# Design Improvement

**FHDI00013**

(Juratek SCA100)

SCANIA: 4 series, G series, K series, L series, P series, R series, S Series

## OEM Design

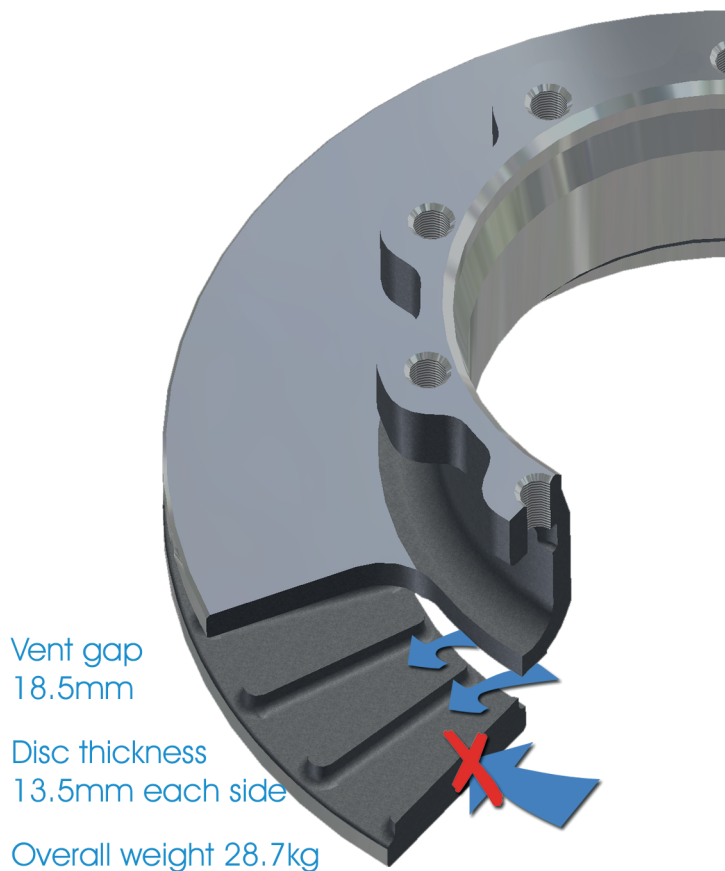
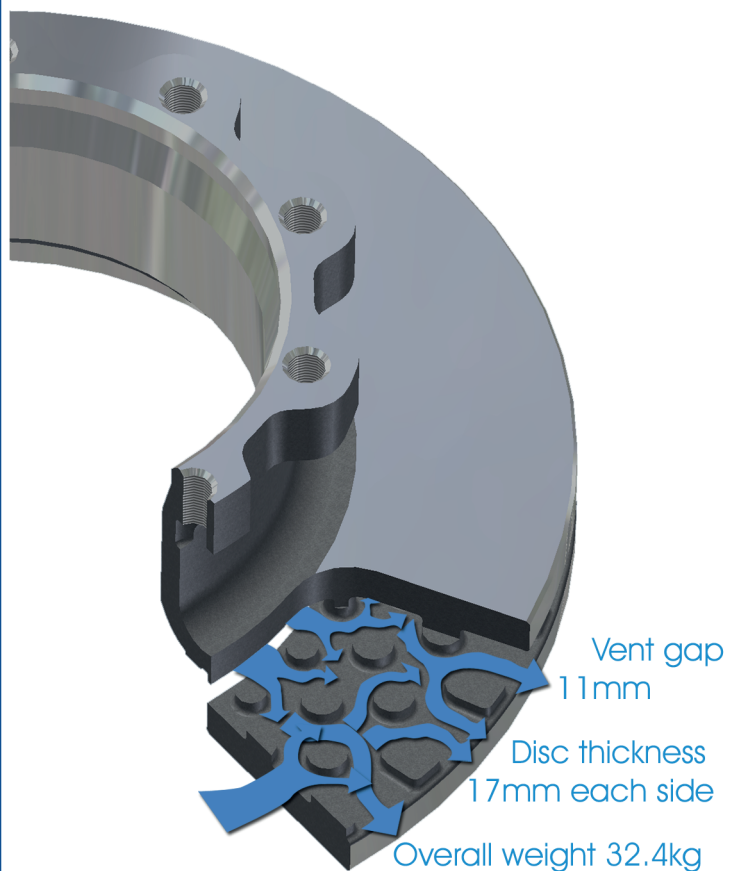
Wall type vents provide poor support for the braking surface, which can result in high spots and thermal cracking.

Airflow travels in one direction only, also increasing the chance of overheating.

Pillar type vents provide greater support for the braking surface, preventing high spots and thermal cracking.

This multi-directional design increases airflow for greater cooling properties. The increased thickness of the braking surface also reduces the risk of thermal cracking.
